**RELICENSING STUDY 3.3.8**

**COMPUTATIONAL FLUID  
DYNAMICS MODELING IN THE  
VICINITY OF THE FISHWAY  
ENTRANCES AND POWERHOUSE  
FOREBAYS**

**ADDENDUM**

**Northfield Mountain Pumped Storage Project (No. 2485)  
and Turners Falls Hydroelectric Project (No. 1889)**

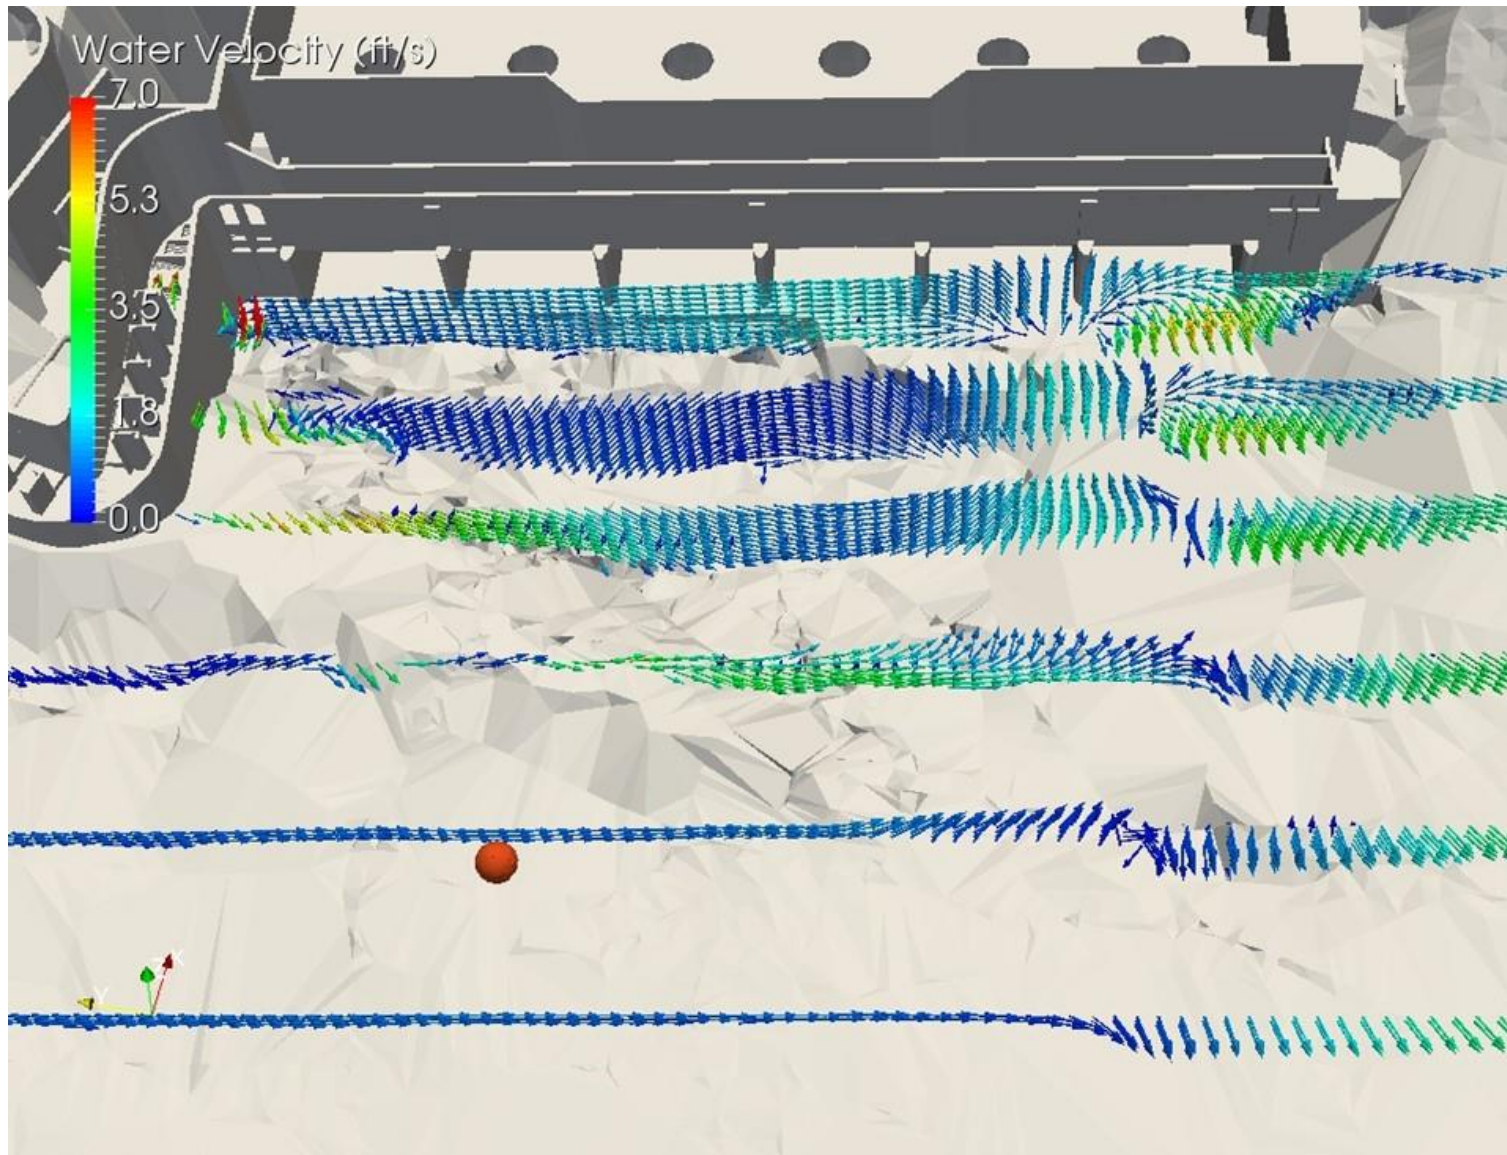
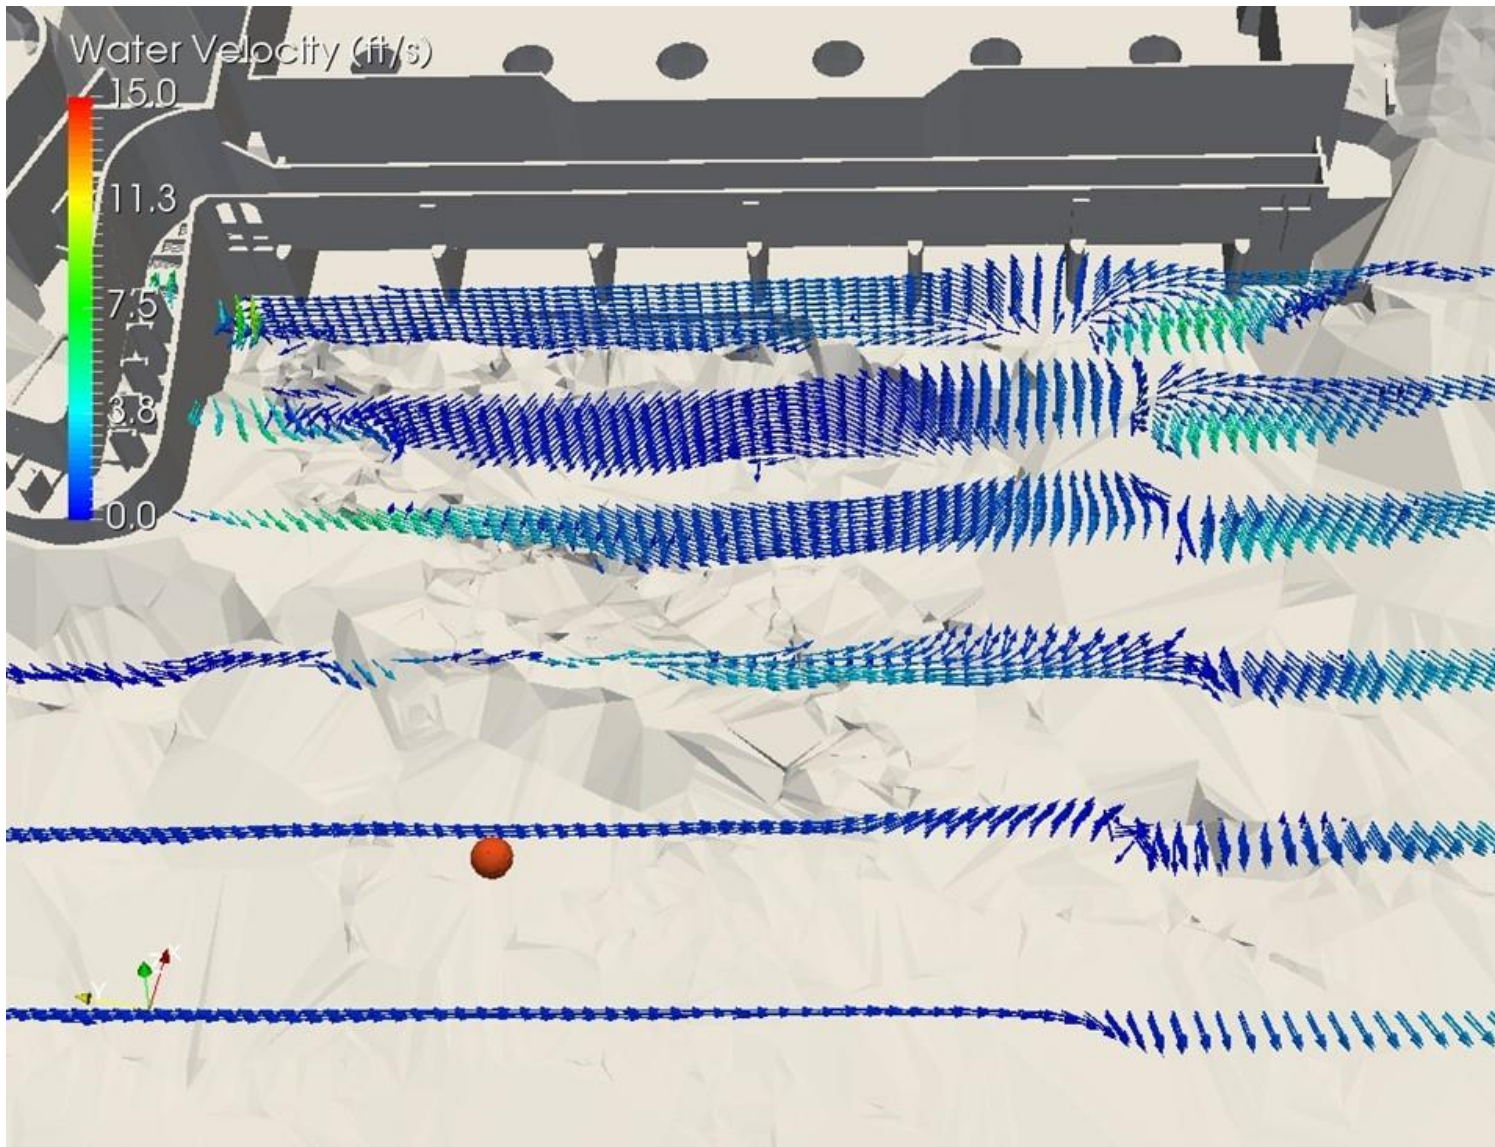
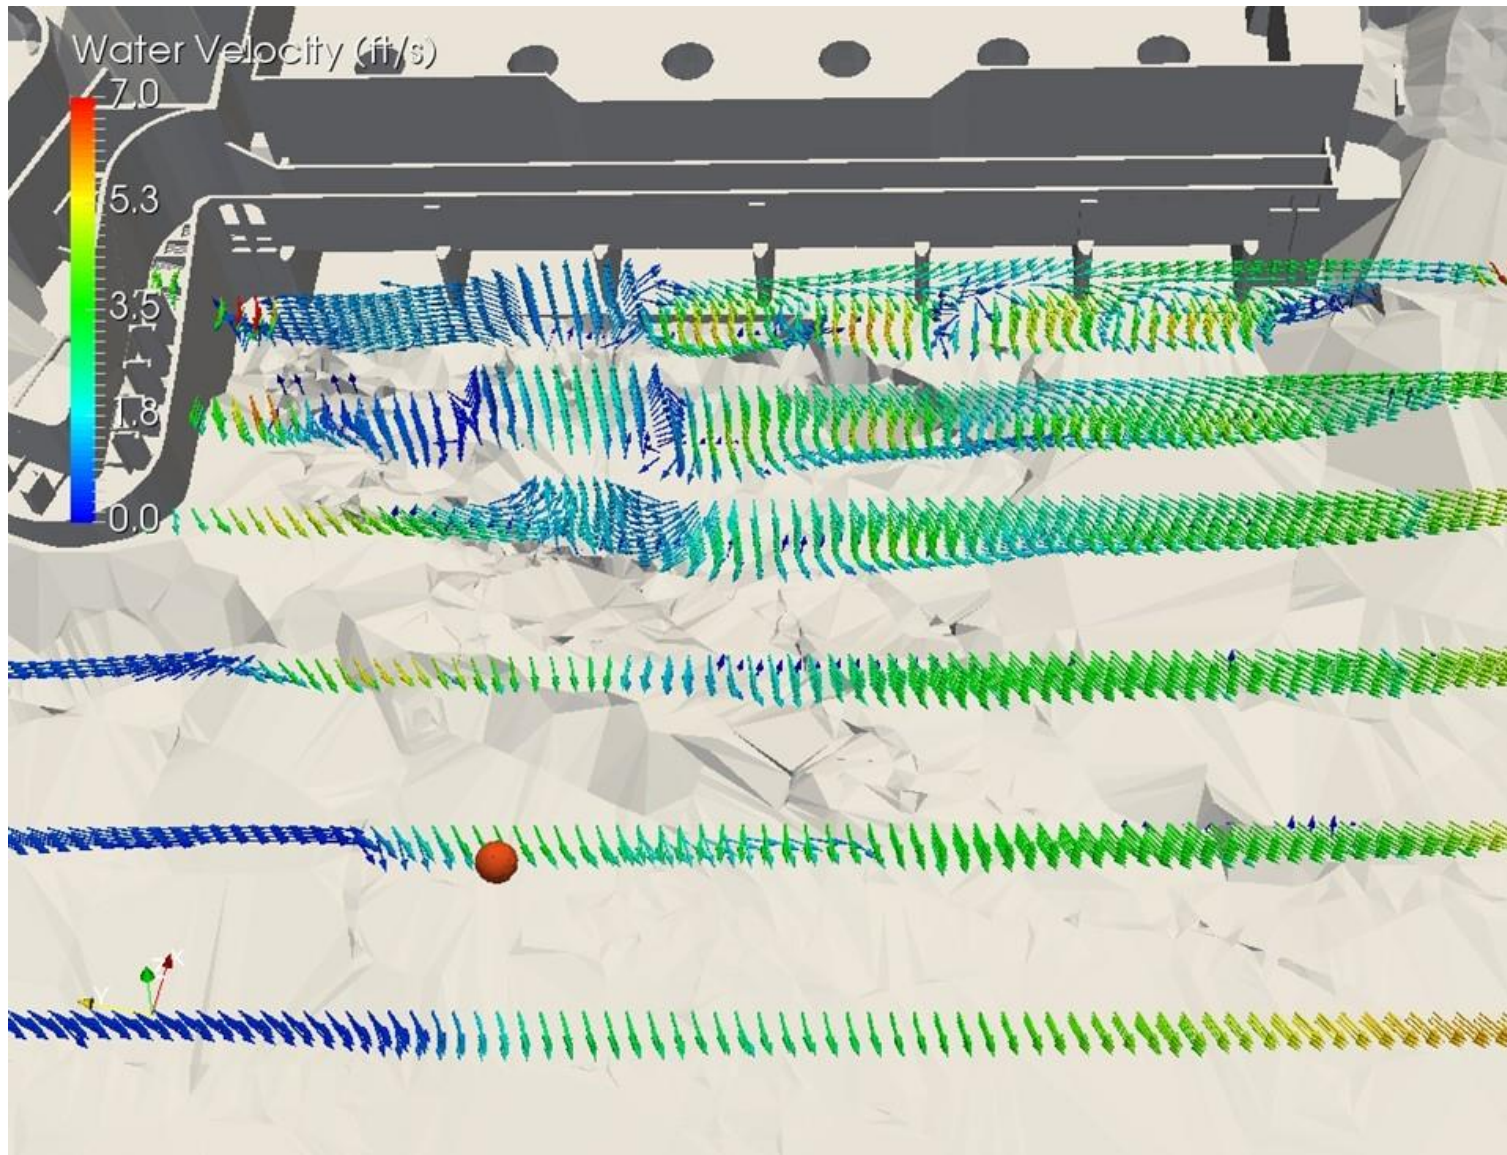
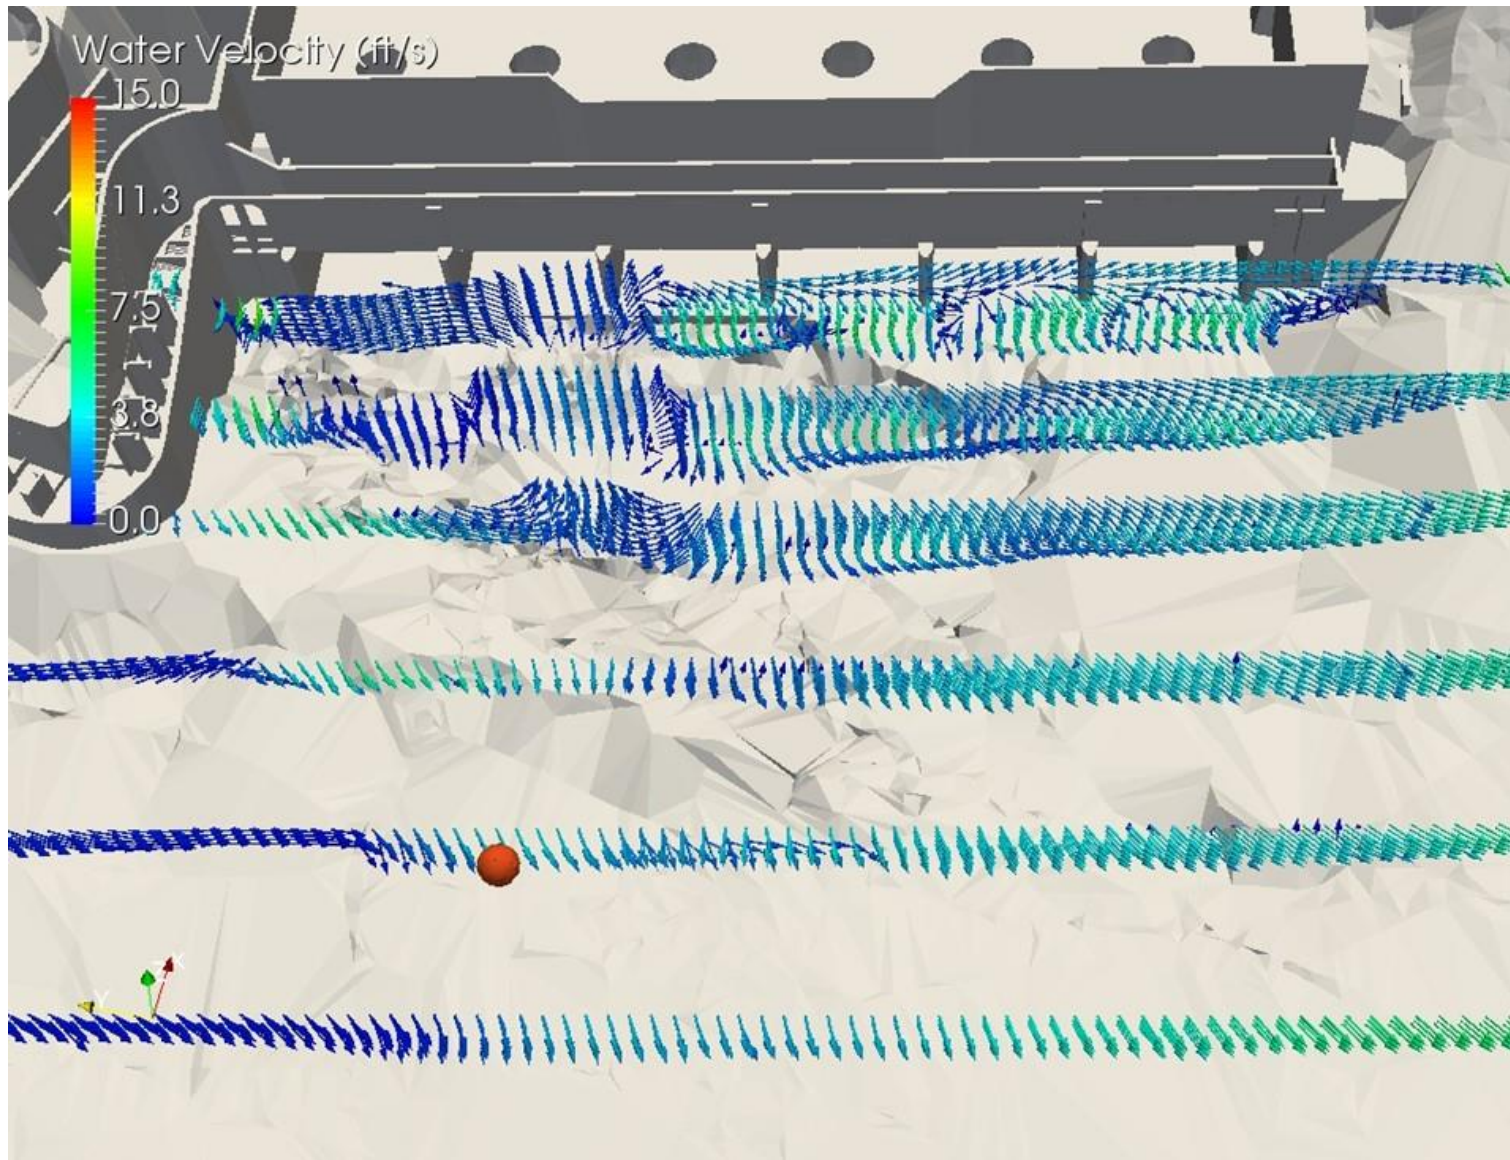
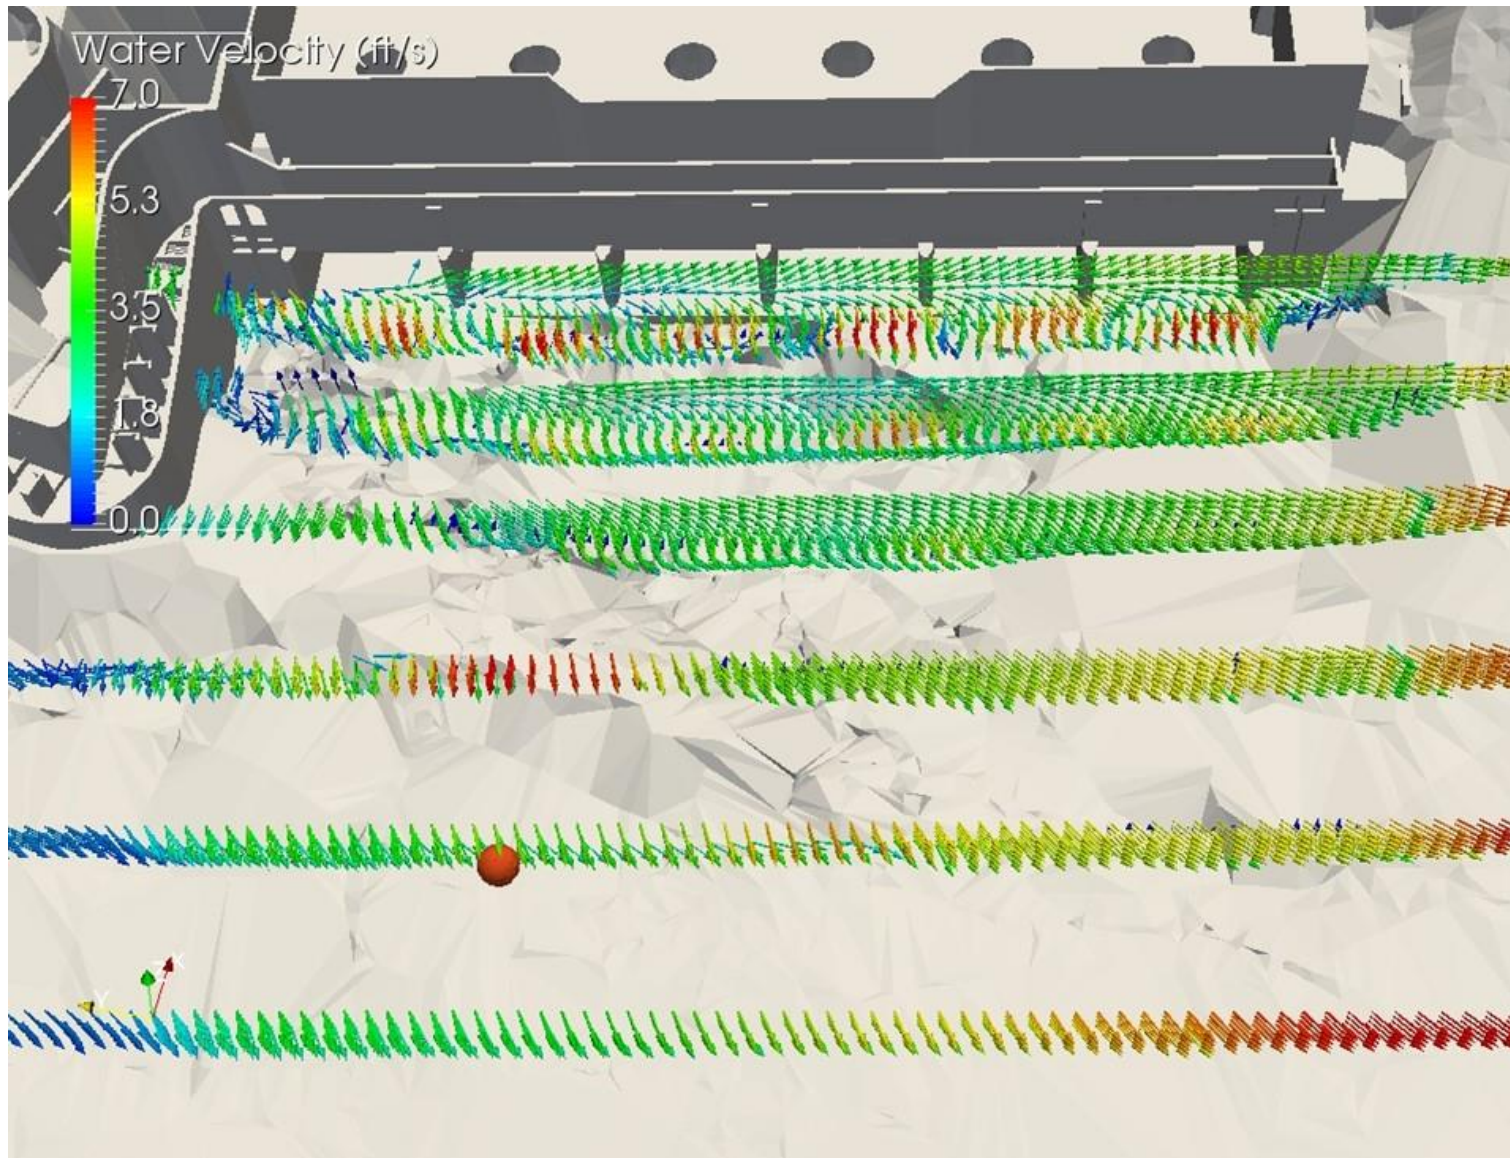
Comment: For Production Runs 5-1 through 5-5: Figure 1 shows the area to be revised for several figures in the report whereby each of these types of figures should be zoomed into the yellow box and another cross section at the red line should be added.

These figures have been generated and are shown in [Figures 2.17-1](#) through [2.17-10](#).
